# Wisconsin Department of Transportation

**Proposal #17: 1491-12-71, WISC 2016 059**  
**Village of Wausaukee**  
**STH 180 – N. Village Limits**  
**USH141**  
**Marinette County**

This is Addendum No. 01, which provides for the following:

Addendum No. 01  
 ID 1491-12-71  
 Revised Sheet 19  
 March 3, 2016

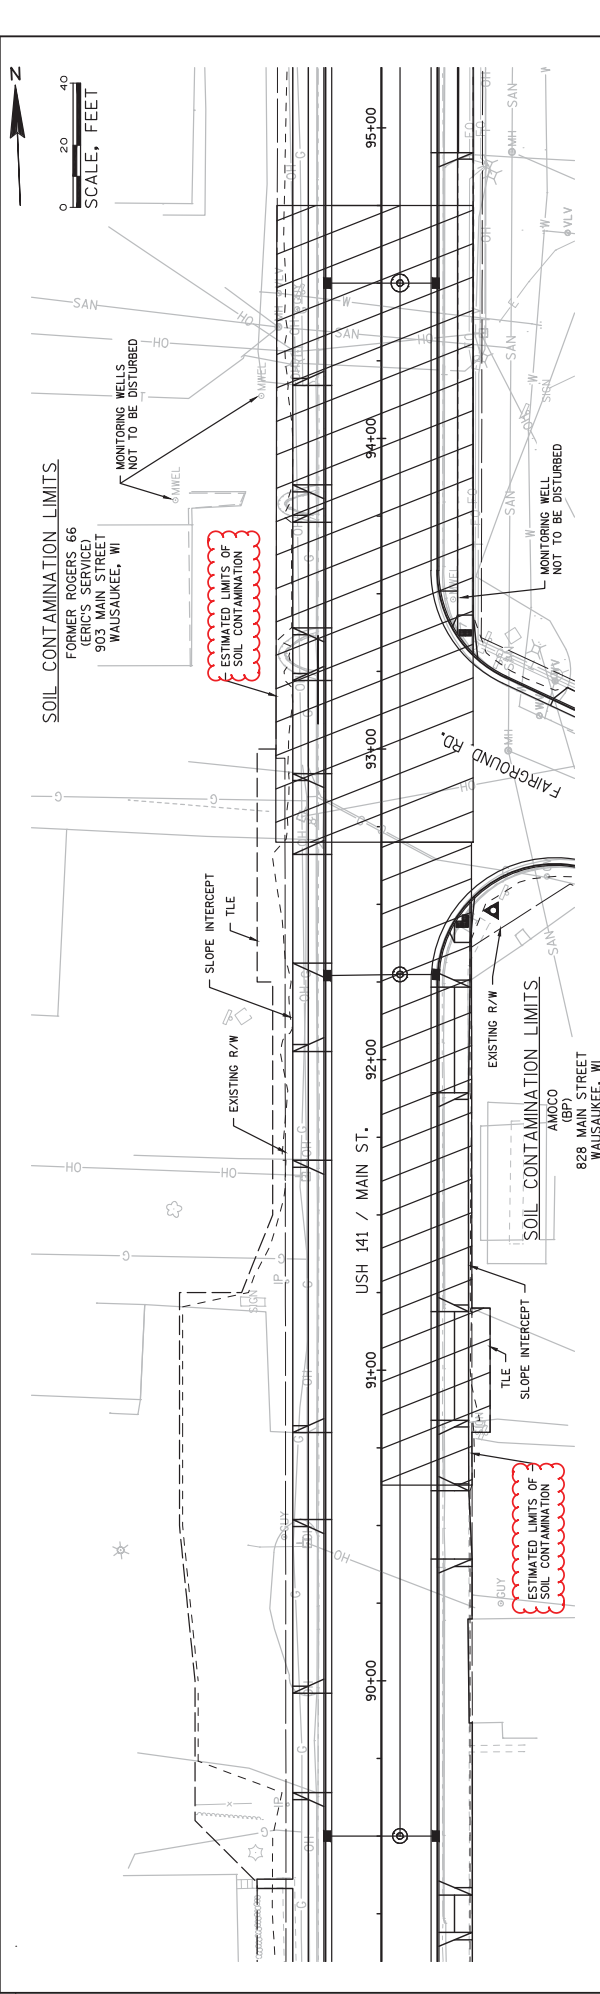
Revised Plan Sheets	
Plan Sheet	Plan Sheet Title (brief description of changes to sheet)
19	Construction Details (The estimated limits of soil contamination have been revised to more accurately represent what areas are thought to contain contaminated soils.)
20	Construction Details (The estimated limits of soil contamination have been revised to more accurately represent what areas are thought to contain contaminated soils.)
50	Streetscape Construction Details (The Stone Paver detail was removed from this sheet and further detailed on sheet 51.)
51	Streetscape Construction Details (The Stone Paver, Perennial, and Tree Details were all modified to show further detailed information)
52	Streetscape Construction Details (Include plan note for landscaping layout responsibility)
102	Miscellaneous Quantities (Excavation, Hauling, and Disposal of Petroleum Contaminated Soils table revised to reflect changes in the estimated limits of soil contamination areas found on sheets 19 and 20.)
